PROJECT APPLICATIONS 10_0129 AND 10_0130

PROPOSED HORSLEY PARK INDUSTRIAL ESTATE.

Proposed Employment Land Development

Jacfin, Burley Road, Horsley Park Project

Plate 1
View west from the Micallef residence
The scale tree is in the centre of the view

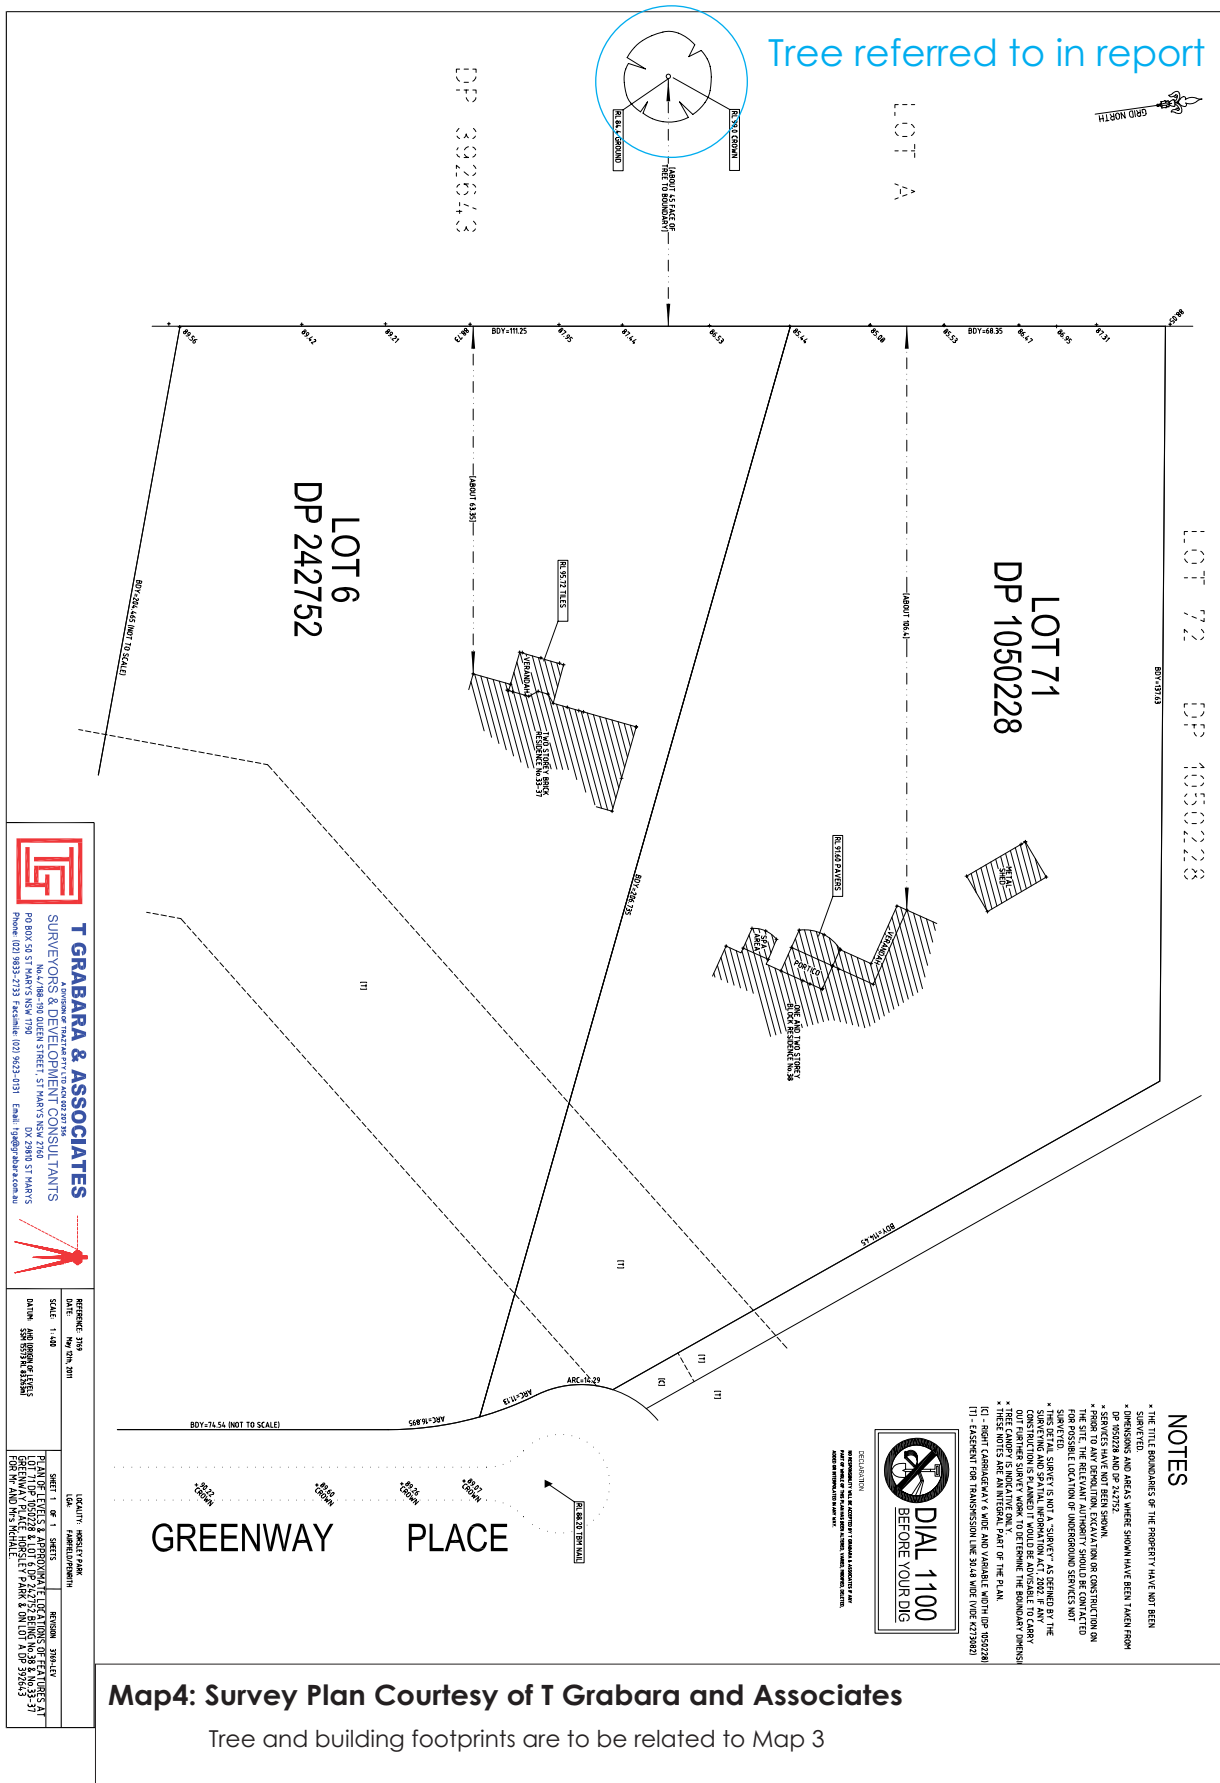
In the photographs, taken by Ms McHale from a standing position on the verandah, the same tree as a scale object can be seen. The canopy of the tree is as high as the mountain horizon in the background. On the basis of the same logic used above, it is clear that the building proposed in the application will block the view toward the Mountains for a standing viewer at the rear of the dwelling, contrary to the claims in Volume 2 of the EAR and in Appendix T. The view blocking effect would be greater for a standing viewer in the rear yard, or a seated viewer inside the residence itself.

| PLAN OF LEVELS & APPROXIMATE LOCATIONS OF FEATURES AT LOT 71 DP 1050228 & LOT 6 DP 242752 BEING NO 38 & NO 33-37 GREENWAY PLACE, HORSLEY PARK & ON LOT A DP 392643 FOR MR AND MRS McHALE | |

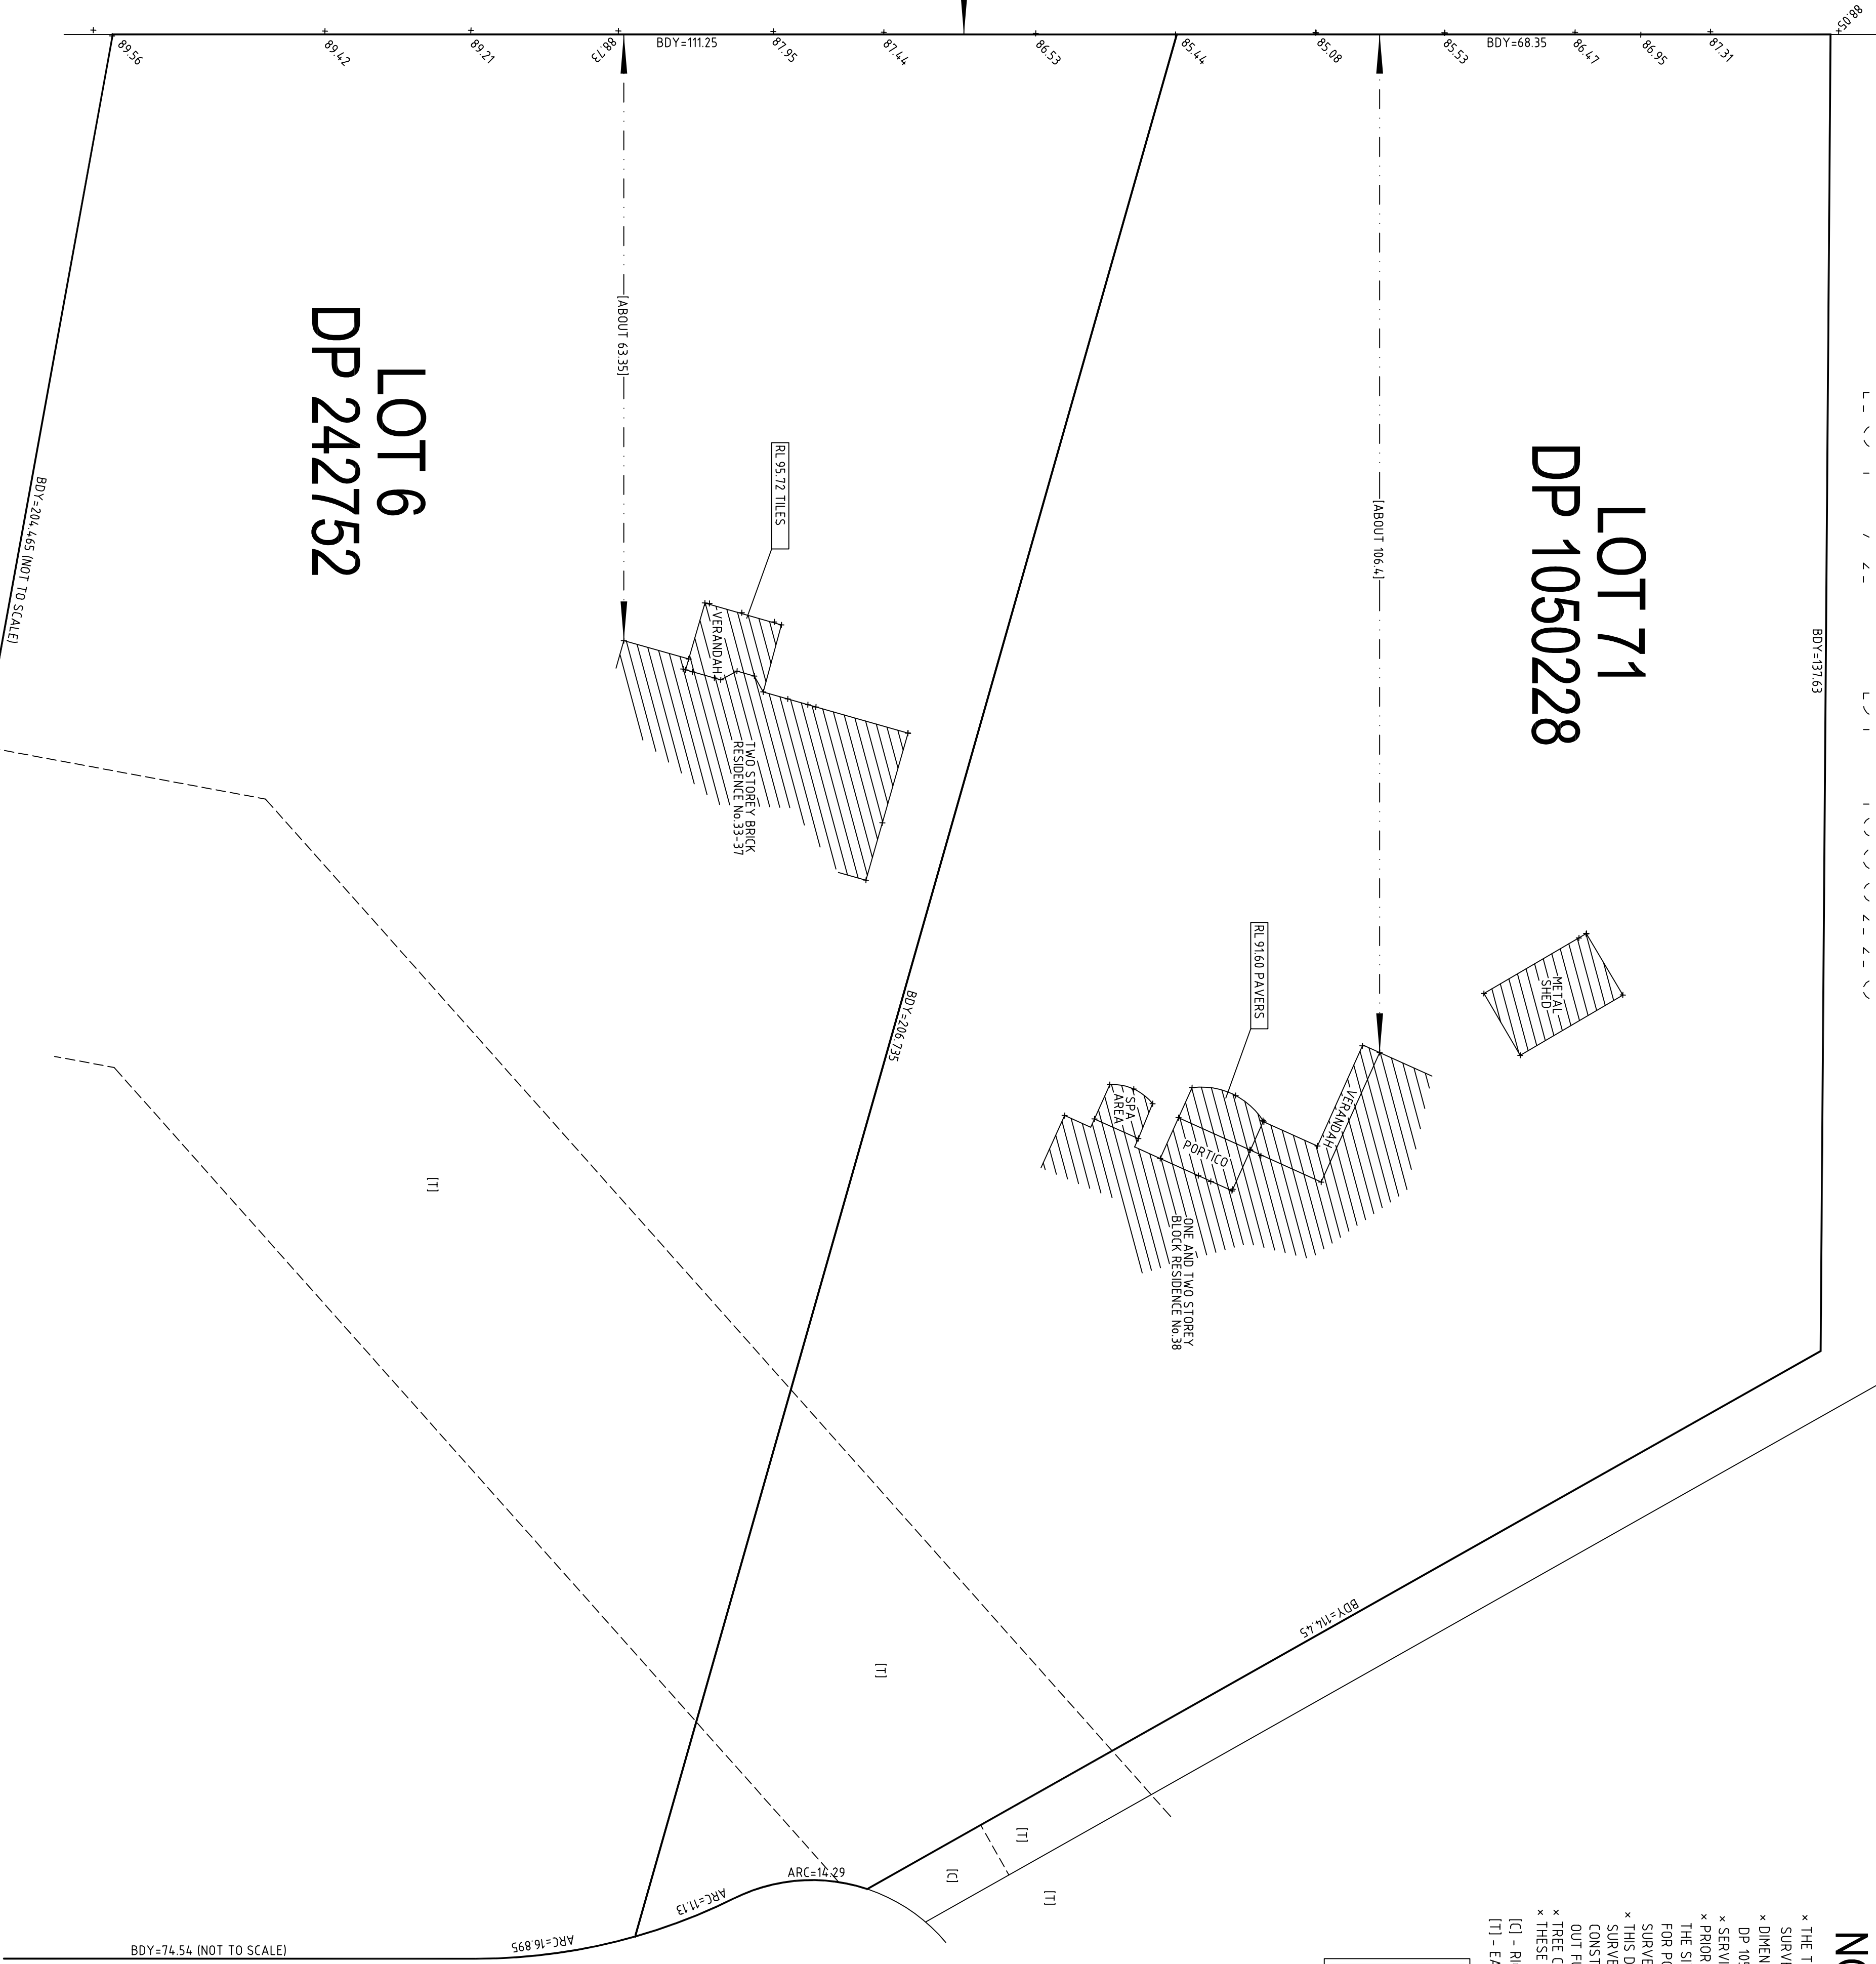
The attached survey plan by T Grabara and Associates shows the floor levels of primary living areas of each of my clients' properties. As a guide to what the likely effect on their views will be, the location and height of a prominent residual ironbark tree in the subject land was also surveyed. The tree is visible in the photographs attached, which depict views from inside each property.

The rear verandah of the Micallef residence has a level of RL 95.72. The Micallef residence has a more expansive view in a horizontal sense than the McHale enjoy. As before, the building pad of the nearest building is at approximately RL 85.
